From: [Rykaart, Maritz](#)
To: [Mark Valeriote](#)
Cc: [Greg Blaylock \(Greg.Blaylock@Newmont.com\)](#); [Goldup, Nigel](#); [Horne, Bill](#); [Klassen, Renata](#); [Miller, Megan](#); [Bay, Hope](#); [Miskolczi, Iozsef](#); [Kurylo, John](#); [Wade, Lowell](#)
Subject: Fillet Zone Construction - Approved Variance
Date: Wednesday, March 30, 2011 12:33:27 PM
Attachments: [Fillet Zone Variance.pdf](#)

Fillet Zone Variance

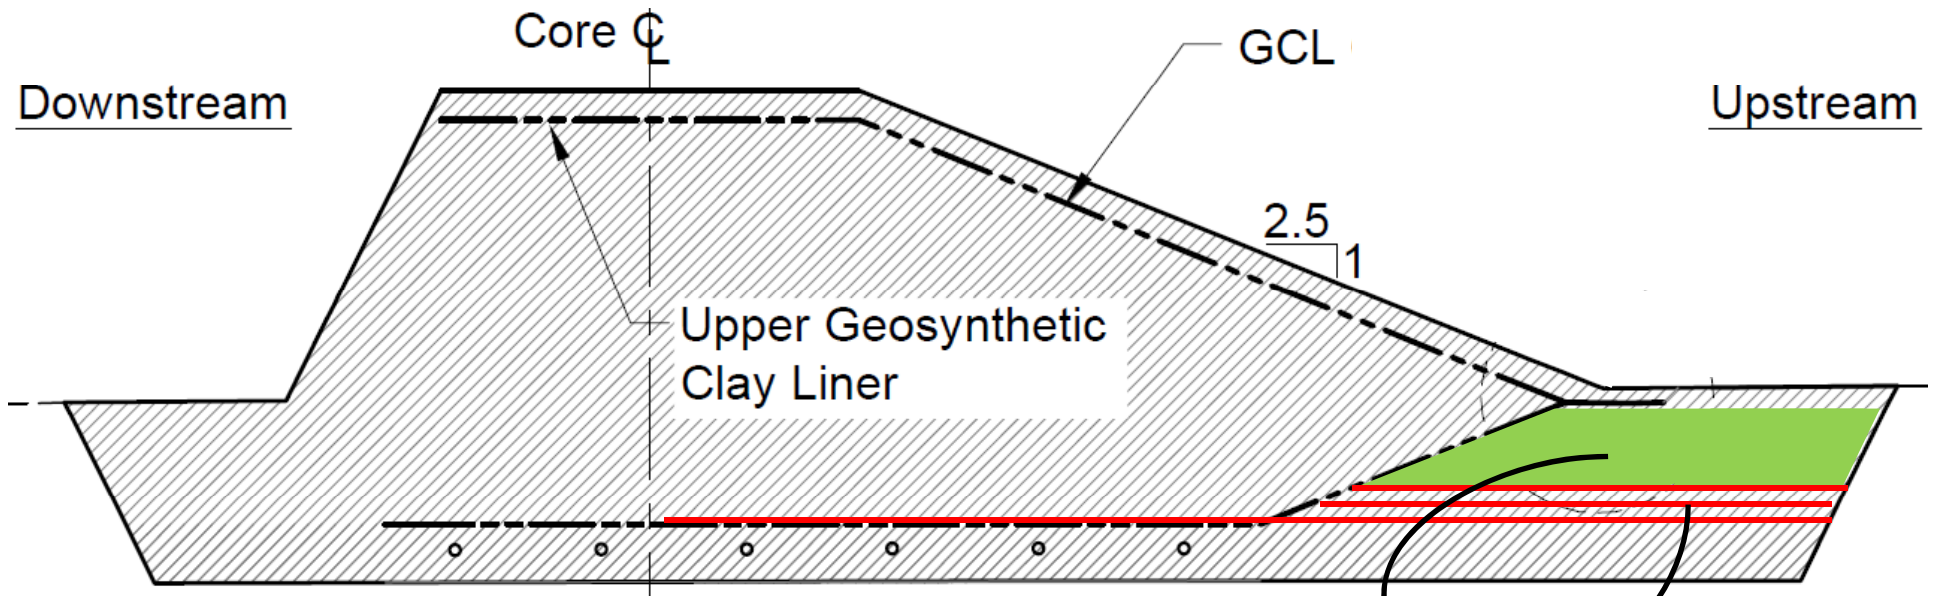
Further to our discussion on site last week during which you requested that SRK consider a variance to facilitate construction of the fillet zone we have evaluated your request and would be willing to accept the following variance (also illustrated on the attached sketch):

1. For the first two lifts (or a minimum thickness of 500 mm) above the GCL base elevation - no variance
2. Thereafter:
 - a. Use blended core material as per rest of core, i.e. no variance on material type
 - b. Ensure 95% Standard Proctor Density
 - c. Moisture content no less than optimum Moisture Content (OMC), but no requirement to meet the 85% saturation
 - d. No freeze back wait period between lifts

Thereafter:

- Use blended core material as per rest of core, i.e. no variance on material type
- Ensure 95% Standard Proctor Density
- Moisture content no less than optimum Moisture Content (OMC), but no requirement to meet the 85% saturation
- No freeze back wait period between lifts

For the first two lifts (or a minimum thickness of 500 mm) above the GCL base elevation - no variance
